**BOARD OF ZONING ADJUSTMENT  
STAFF REPORT**

**CASE NUMBER** 6475

**APPLICANT NAME** Lee Waldrop

**LOCATION** 455 South Broad Street  
(East side of South Broad Street, 106'± South of Elmira Street).

# PROPOSED SITE PLAN

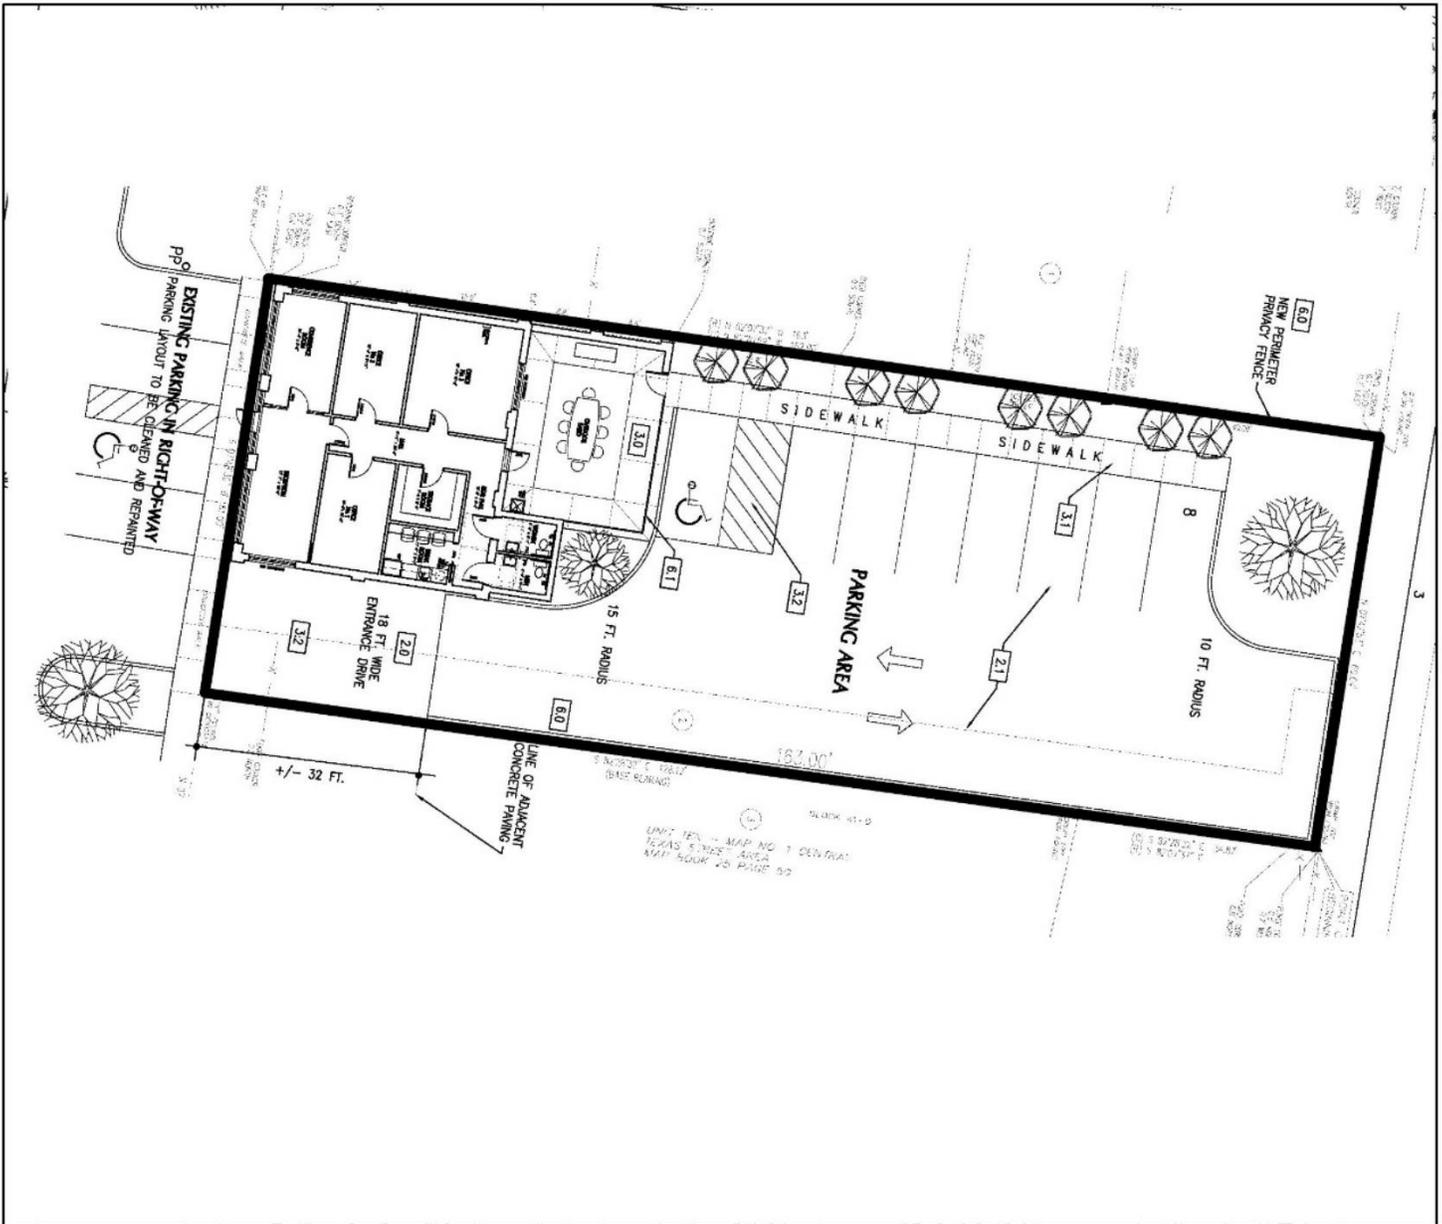
by parking spaces located entirely in the right-of-way, and the applicant proposes to utilize property behind the existing building to provide parking on private property, as required by the Zoning Ordinance. It should be noted that the site plan submitted for permitting shows compliant paving for access and parking as being proposed for the site, whereas the site plan submitted with the variance application depicts gravel for the proposed parking area. No additions are proposed to the existing structure at this time, and the site plan depicts a compliant number of parking spaces available on-site, making the provision of parking in the right-of-way unnecessary. If approved, the existing parking in the right-of-way should be removed. Finally, based on City of Mobile aerial photos of the site, it appears that the rear of the site has recently been cleared, without permits. If approved, the applicant should obtain any required after-the-fact permits.

It should be noted that the property has R-1, Single-Family Residential District property that abuts the rear property line of the subject site. The site plan submitted depicts an existing chain link fence along this property line, with a six-foot tall privacy fence proposed. If approved, the buffer should be retained on the site plan.

Neither the site plan submitted with the variance application, nor the plan submitted for permitting depict a dumpster, but there are notes regarding provision of a dumpster. If approved, the site plan should be revised to either depict a dumpster with a compliant enclosure and sanitary sewer connection, or include a note stating that curbside pickup will be utilized.

As the structure has existed in its current configuration for 40 years, it may be reasonable to allow the site to be served by a sub-standard access drive. However, there is no hardship associated with the property that would make the provision of gravel surfacing over asphalt or concrete preferential. The applicant has even had a site plan created showing the site can be developed in a compliant manner. As such, this request should be denied, and the applicant should be required to provide compliant surfacing materials.

- 1) Obtain any after-the-fact permits needed for clearing the property;
- 2) Revision of the site plan to depict compliant parking and maneuvering surfaces;
- 3) Retention of the compliant residential buffer along the rear property line;
- 4) Removal of the existing parking spaces in the right-of-way;
- 5) Revision of the site plan to either depict a dumpster with a compliant enclosure and sanitary sewer connection, or include a note stating that curbside pickup will be utilized; and
- 6) Full compliance with all municipal codes and ordinances.
